5. Individual Letter Responses

January 17, 2025

Re: Revised Draft Tiered Environmental Assessment for SpaceX Starship/Super Heavy Vehicle Increased Cadence at the SpaceX Boca Chica Launch Site in Cameron County, Texas

Figure 5-4. Road Closures and Checkpoints in Relation to National Wildlife Refuges

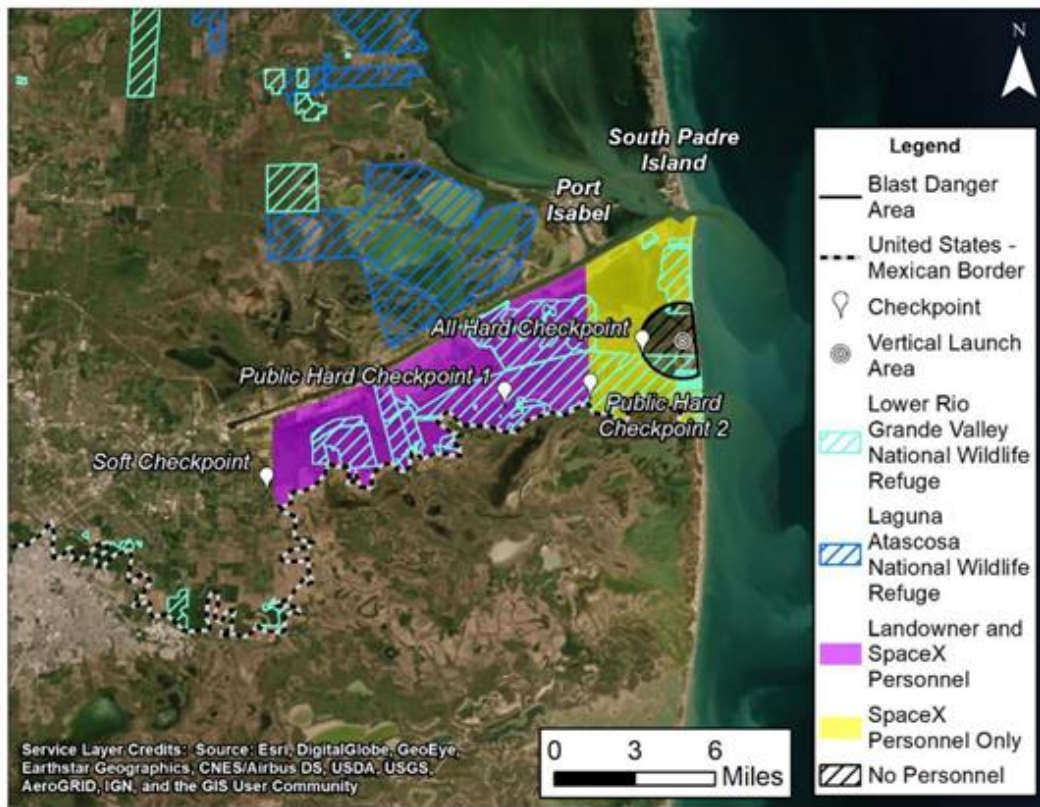
LRGV NWR has been repeatedly forced to shut down operations during SpaceX's testing and launch activities, which prevents the Service from adequately managing the refuge and precludes visitors from enjoying these public lands. The newest proposal assessed in the DPEA anticipates 800 hours of annual closures—500 for testing and 300 for debris retrieval. During closure times, LRGV NWR staff are not allowed to access the refuge, but SpaceX personnel would be. Below is a map that was included in the Biological Assessment, which shows the launch site and closure areas:

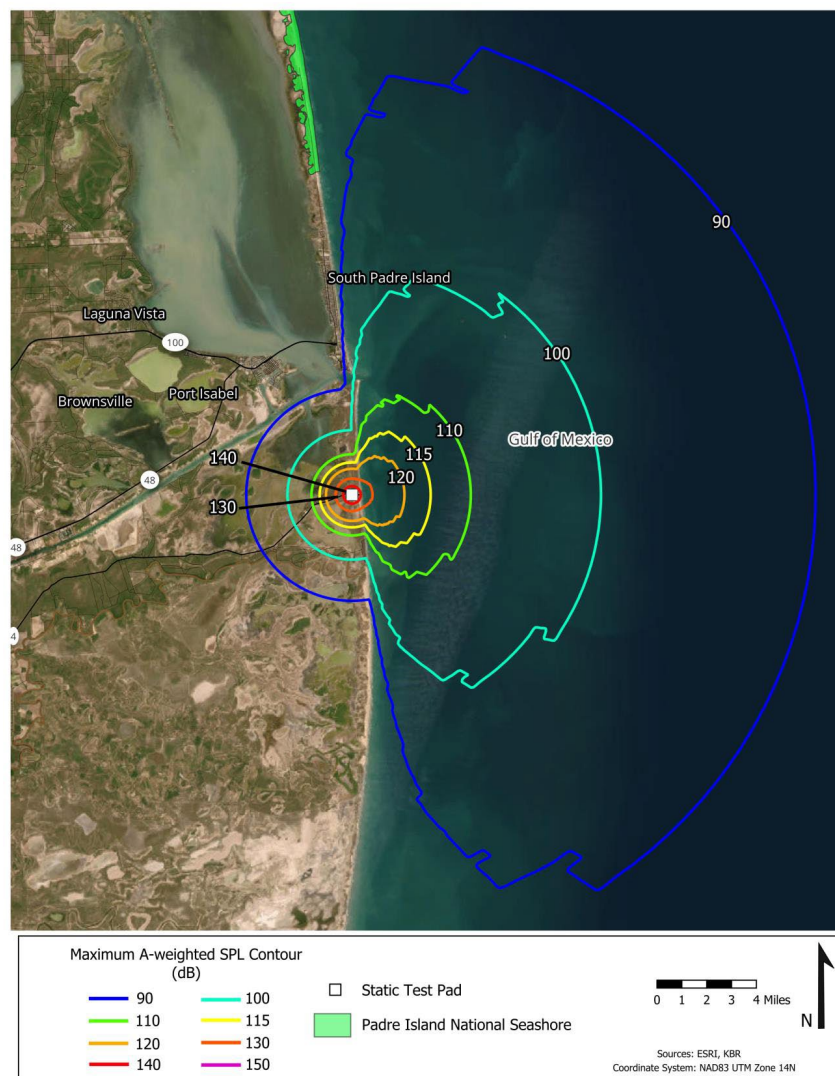
Since sound that is reflected will be louder and propagate further than sound that is absorbed, the accuracy of noise modeling depends on the model using appropriate ground impedance between the source and the receiver. The choice of ground cover for the model therefore has a drastic impact on the projected noise levels, particularly the noise levels of the static fire tests such as depicted in Figure 18 of the *Noise Assessment* (see Figure 1 below).

Basically, the *Noise Assessment* is claiming—without any disclosure, documentation, or evidence—that it accurately identified the appropriate ground impedance value for the most common ground type in the vicinity of Boca Chica, TX. The *Noise Assessment* doesn’t document the actual ground cover type or the ground impedance used in the modeling, but it is clear from Figure 1 that the ground impedance value for areas other than the Gulf were absorptive (i.e., ground cover that absorbs noise and reduces noise levels). Otherwise, there would not be such a dramatic difference in the noise contours between the Gulf and inland areas, as the EA notes in the quote above from page 6.

Figure 2: Figure 6 Access Restriction Area, from the EA.

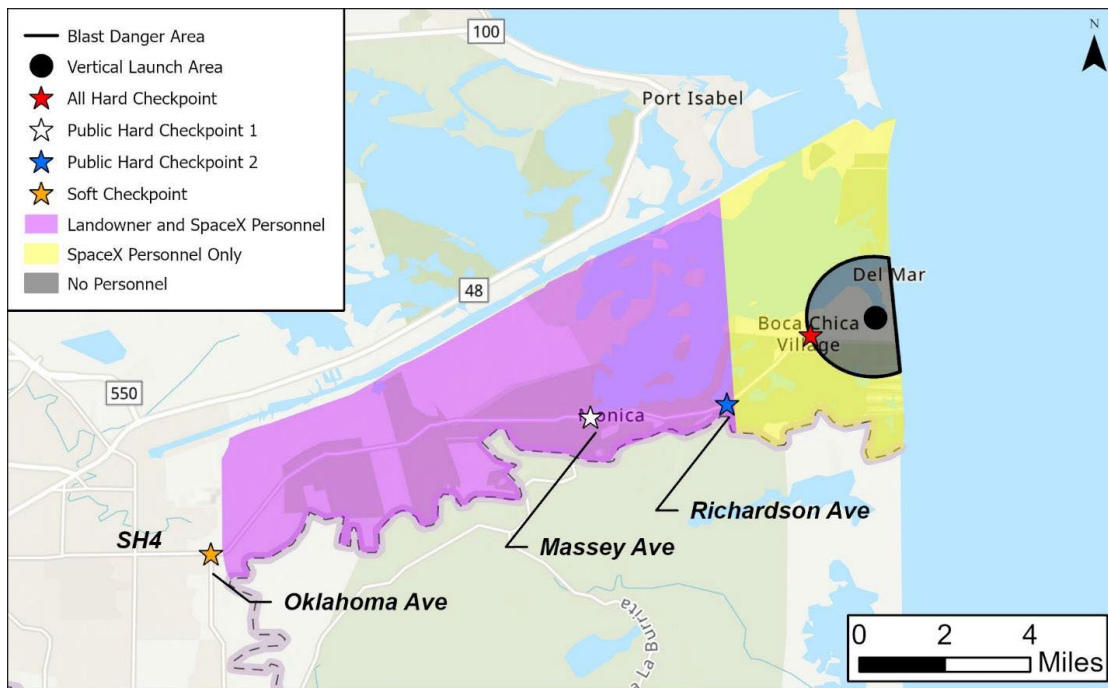
The problem is, most of the nearby “ground” that is north and west of the launch facility is actually reflective, because it is water—specifically South Bay, Bahia Grande, and Laguna Madre. As Figure 6 of the EA demonstrates, the authors of the EA knew that most of what they were modeling as absorptive ground was actually hard, reflective water. See Figure 2 below.

Figure 3. Figure 6 Access Restriction Area, from the EA, using National Oceanic and Atmospheric Administration open water data.

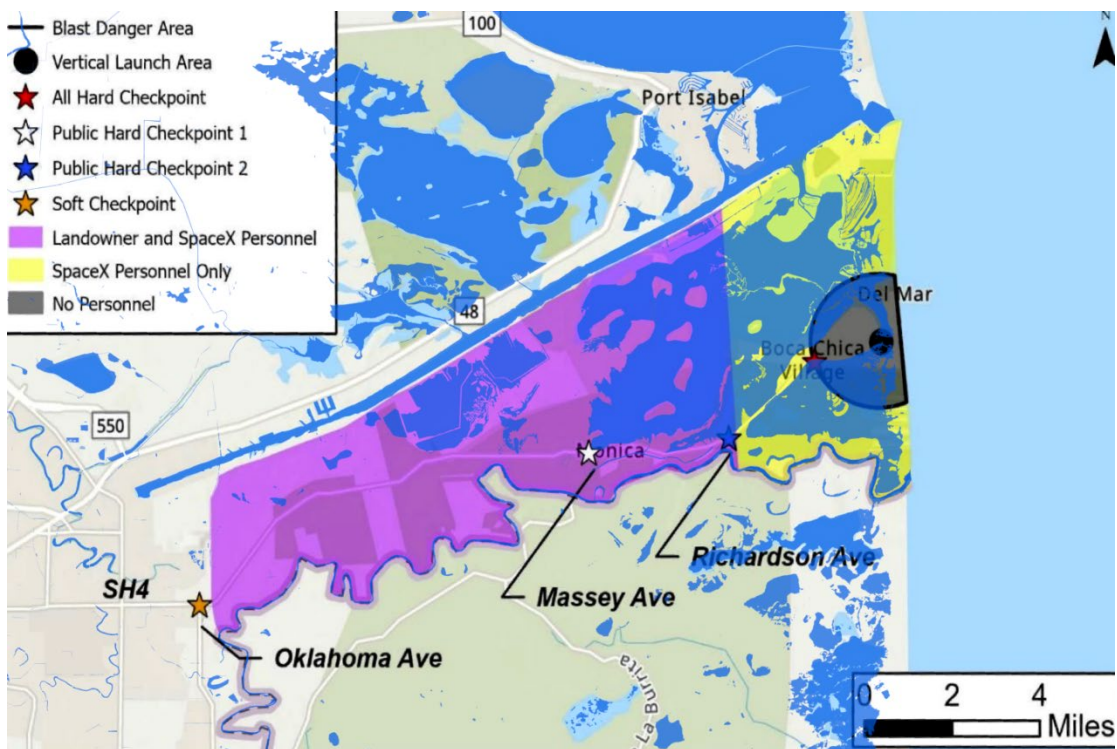
Figure 3 below shows more clearly the water in relation to the launch facility. It uses the original Figure 6 roads, key, and categories, but is superimposed on a National Oceanic and Atmospheric Administration dataset showing open water.⁴

It is clear from Figure 3 that the most common ground cover type in the vicinity of Boca Chica, TX is water. In fact, water makes up 55% of the surface area within the inland portion of the 90 dBA contour found in Figure 18 of the EA. See Figure 4 below.

Figure 4. Figure 18 of the *Noise Analysis* 90 dBA Contour Line. The non-Gulf surface area within the orange line, the inland area that exceeds 90 dBA, contains approximately 20,700 acres, while the open water within that area accounts for approximately 11,500 acres.

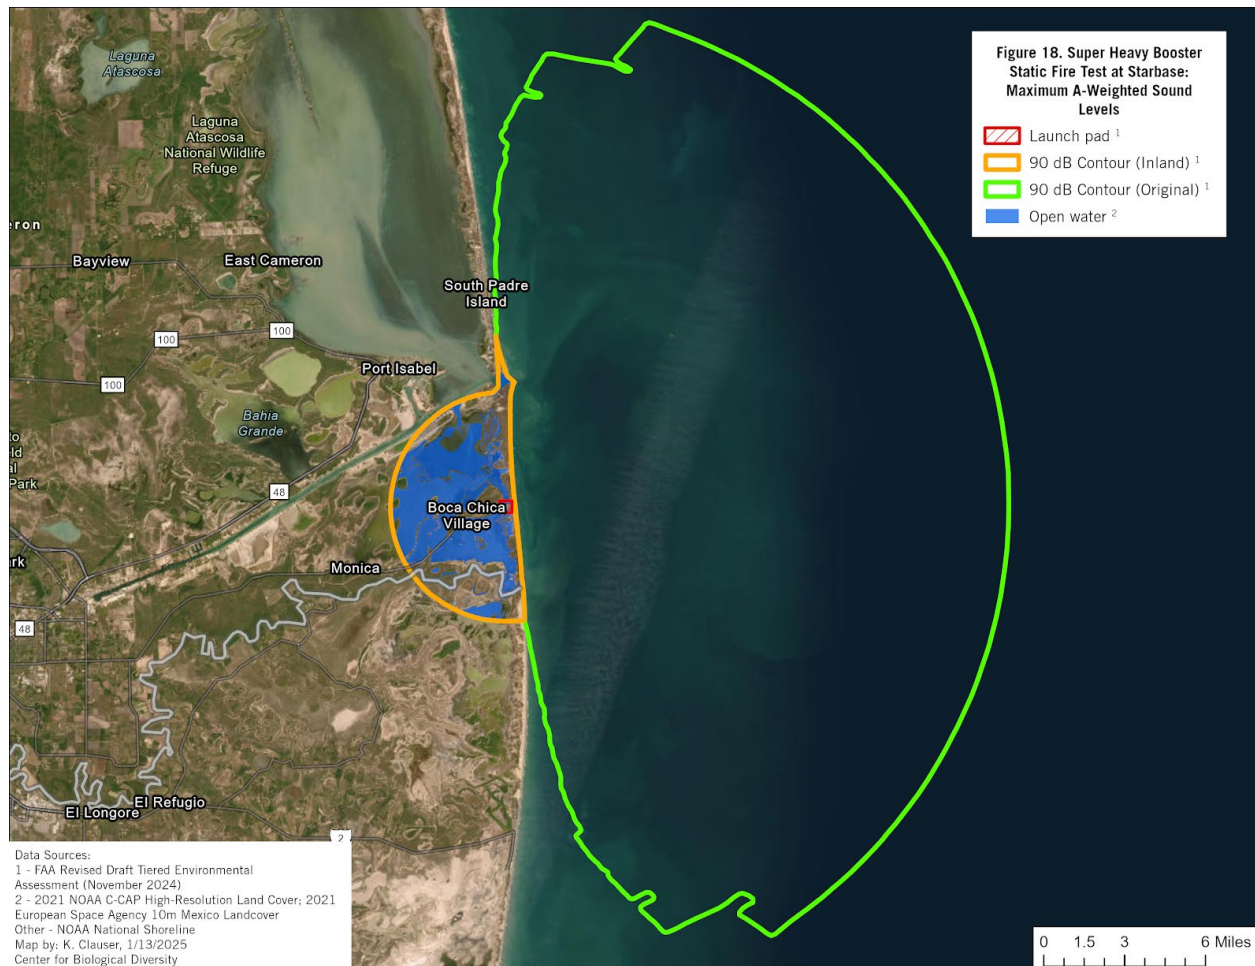
The model erroneously defines areas as absorptive when in fact those areas will not absorb noise, but rather reflect it. Had the EA accurately modeled South Bay, Bahia Grande, Laguna Madre and other smaller areas of open water as reflective water, like it modeled the nearby water to the east (the Gulf), one would expect the contour lines, particularly to the north and west, in Figure 1 to be similar to those over the similarly hard water of the Gulf. This would drastically change the results of the noise model, since if the ground cover were properly modeled, higher noise levels would be experienced in populated areas. This is particularly true for the static tests, in which case the angle of incidence is low.⁵ The number of people exposed to each noise level should have been disclosed by the EA, but were not provided or disclosed. Those values, however, surely factored into the EA's decision-making process. It is very likely,

Figure 5. The Surface Area between Launch Site and Port Isabel. There are approximately 7,100 acres of open water compared to a total of 13,000 acres total within the red highlighted area.

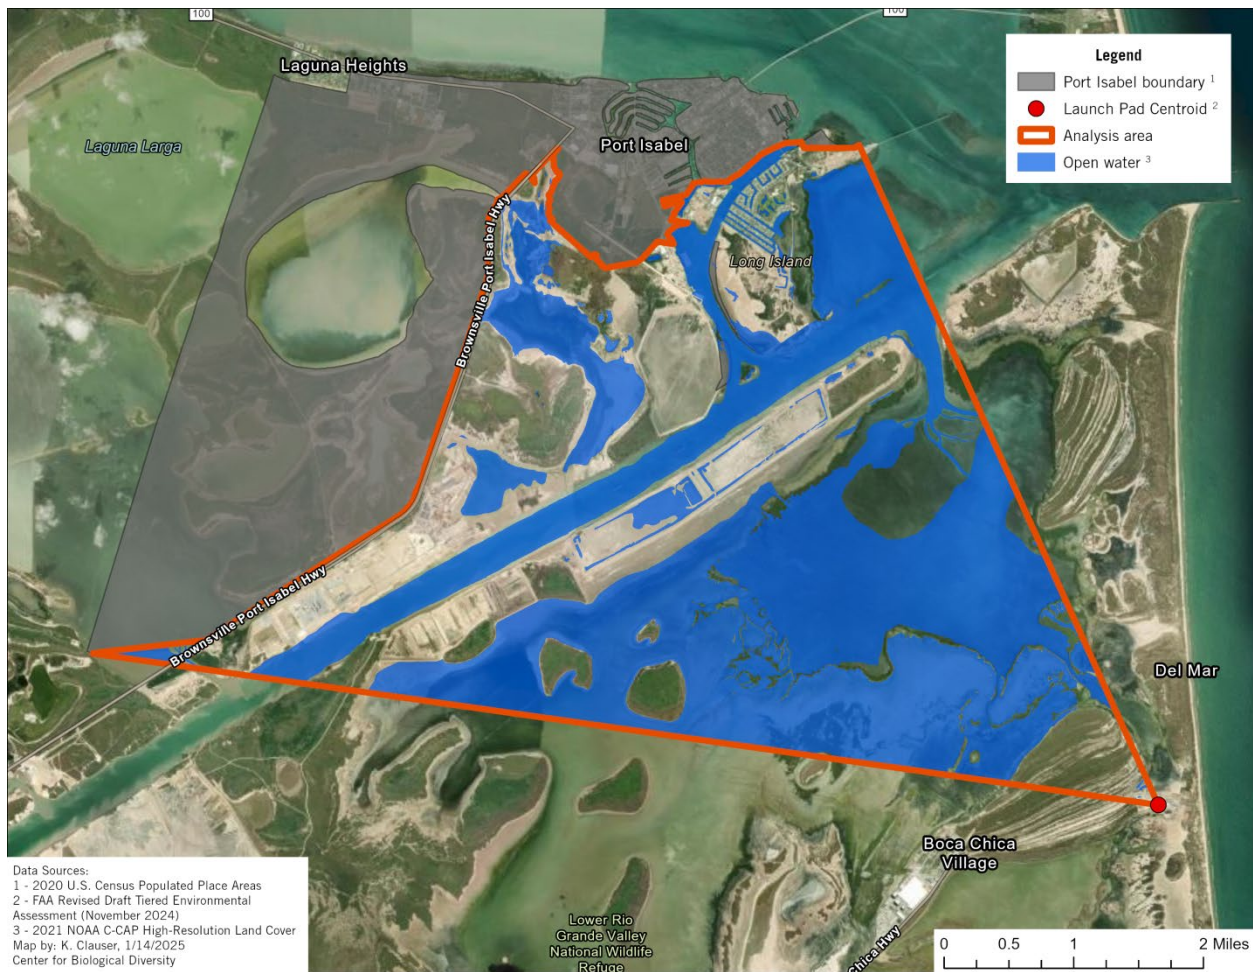
Similarly, analysis of a wedge drawn from the launch site to Port Isabel, the path noise would follow from the launch site to Port Isabel, indicates that the intervening area is 55% water. See Figure 5 below.
